Addendum No. 1

Project Name: N5012(1)1,2&4 Road Improvement Project in Sanostee, NM

Owner: Navajo Division of Transportation

4. Sheets 2, 3, 5, 8, 11, 17, 18, 19, 38, 39, 40, 61A, 61B, 65 and 66 of the N5012(1) plans have been revised. Revisions included changing the class of riprap from "Class 2" to "Class 1" and adding in the subgrade stabilization notes from the Pre-Proposal Meeting Agenda.

REGION	STATE	RESERVATION	ROUTE	PROJECT NO.	SHEET	TOTAL SHEETS
NORTH	NEW MEXICO	NAVAJO	N5012	N5012(1)1,2&4	66	75

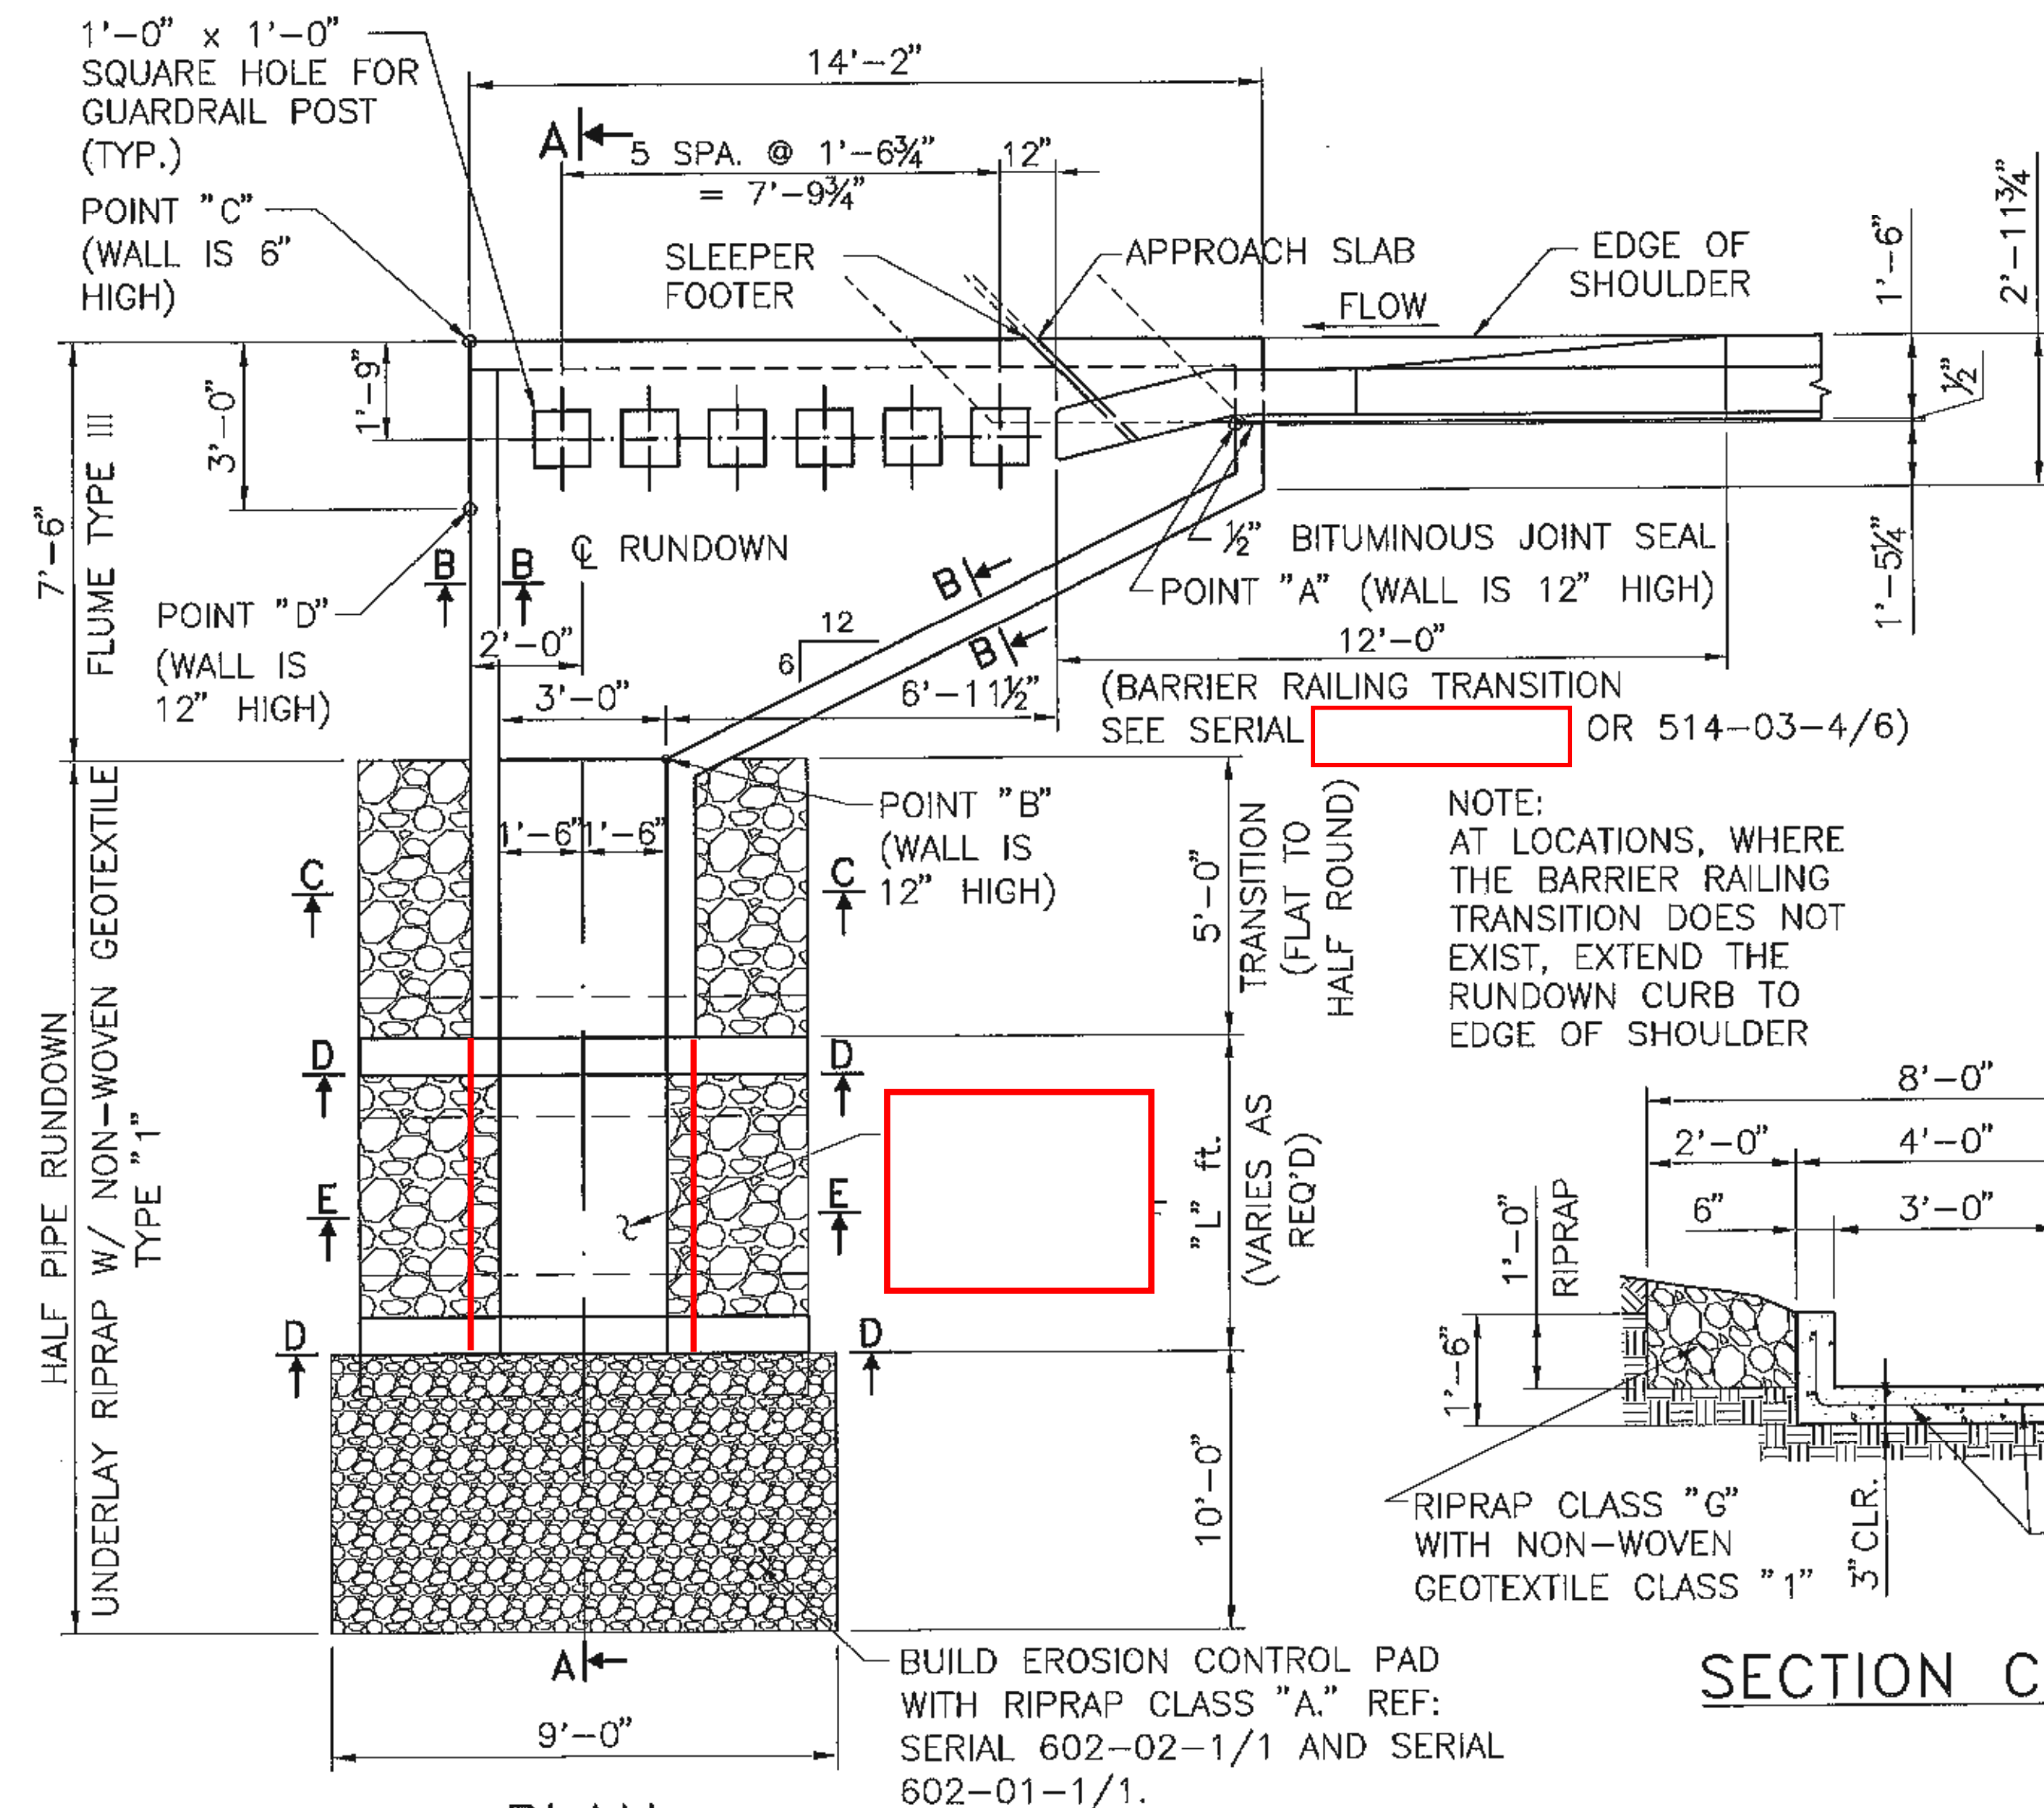
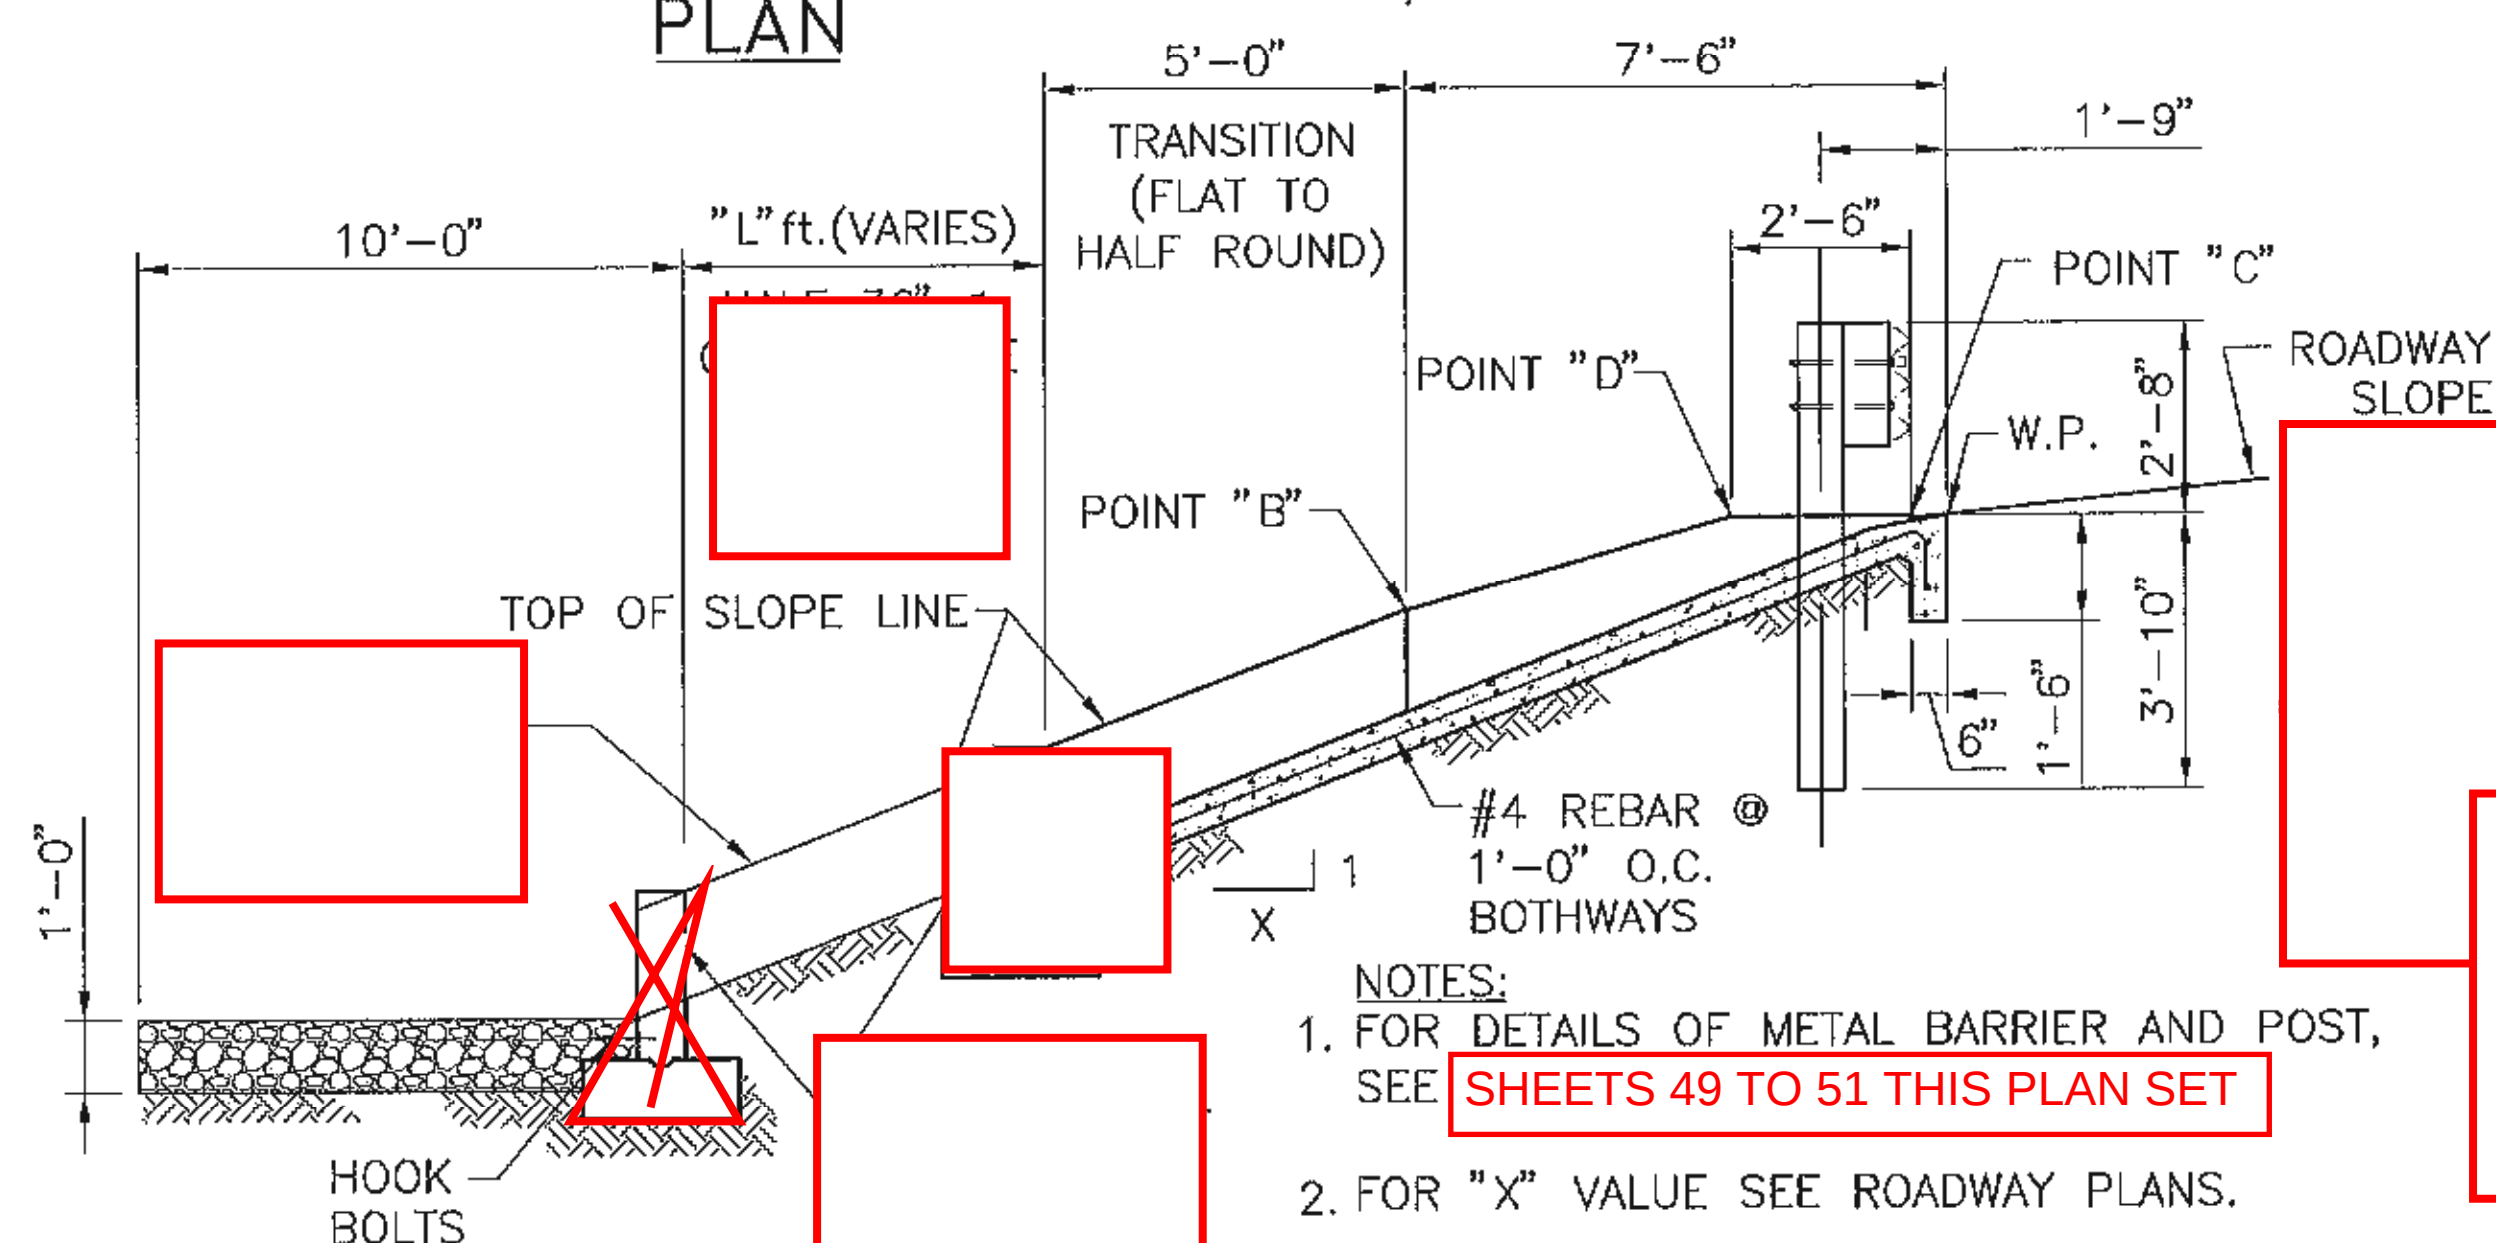
NOTE: REFERENCES WITHIN THIS SHEET TO CLASS "A" RIPRAP IS EQUIVALENT TO BID ITEM 25112-2000 WIRE-ENCLOSED RIPRAP, CLASS 1.

NOTE: REFERENCES WITHIN THIS SHEET TO CLASS "G" RIPRAP IS EQUIVALENT TO BID ITEM 25101-0100 PLACED RIPRAP, METHOD A, CLASS 1.
